CERTIFICATE OF APPROPRIATENESS

Applicant: Sebastien L Dreyfus, owner, and Mark Schatz agent

Property: 1029 Arlington Street, Lot 4, Block 219, Houston Heights Subdivision. The property includes a historic 1,500 square foot, one-story wood frame single-family residence situated on a 6,600 square foot (50' x 132') interior lot.

Proposal: Alteration – Addition, Existing one-story shed roof addition received a COA in April of 2013 for the northwest rear corner. Construct a two-story 1,200 sq ft addition at the rear of the original house:

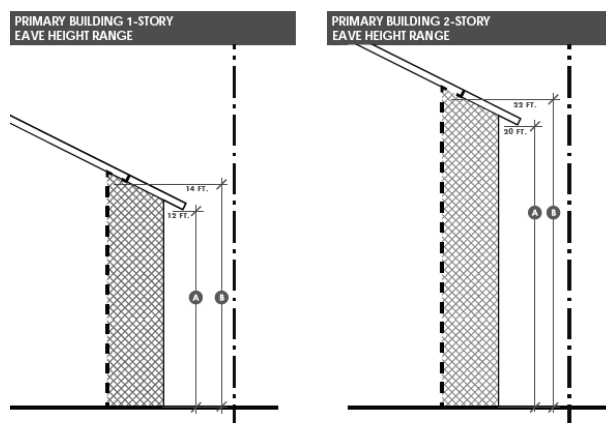
- North elevation has no inset as the side wall is 40 and there's a later addition to the original home.
- South elevation has an inset length of 6'-3 1/2" and an inset depth of 3'-1 1/2"

North Elevation: Existing. C.2013 addition has already absorbed historic corner – not applicable
South Elevation is inset 3'11"

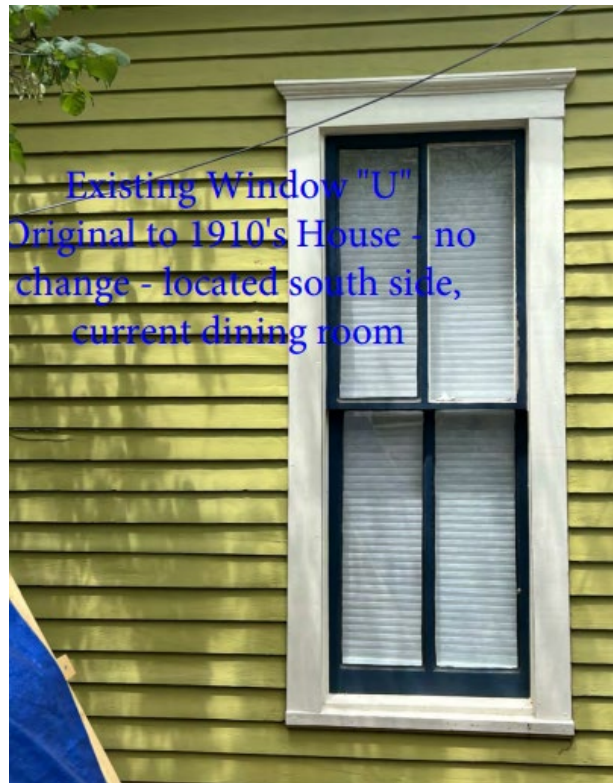
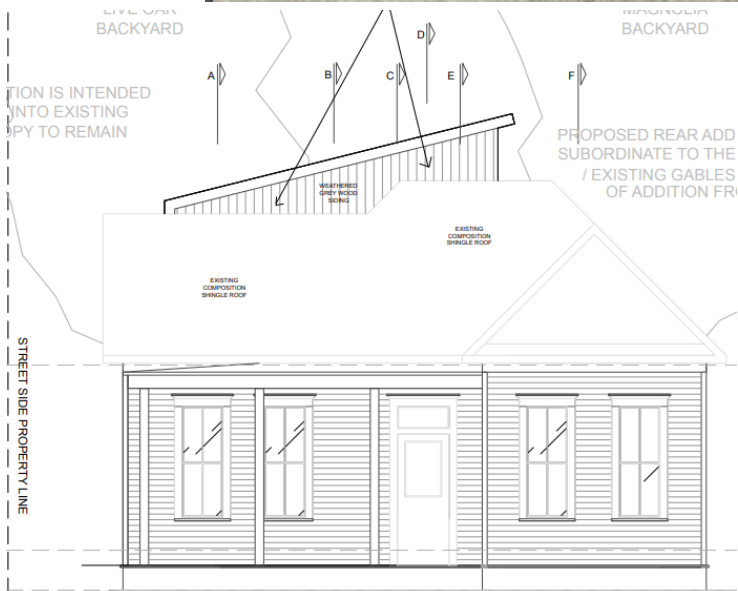
I have a graphic mistake on the north side: the two windows shown close together that you have highlighted = that is incorrect: there is only the one existing unit to the right, highlighted. The "original house" graphic is imported from the 2012 bathroom room project & in reality the builder for that project did NOT add that window in, which would have gone into the new master closet. So the graphic showing the addition is the one that actually has the correct graphic for the existing windows on that north wall.....

On the south, where the current kitchen is located, the Owner's intent is to literally **custom fabricate wood windows to match the other original 1910's house windows in that same wall** = make them all identical, both in terms of materials, sizes, method of construction, color, etc. = intent is those units would be exact replicas of the original windows adjacent. The 1980's remodel window in the kitchen there would be replaced by one of the two new proposed built-to-match units....
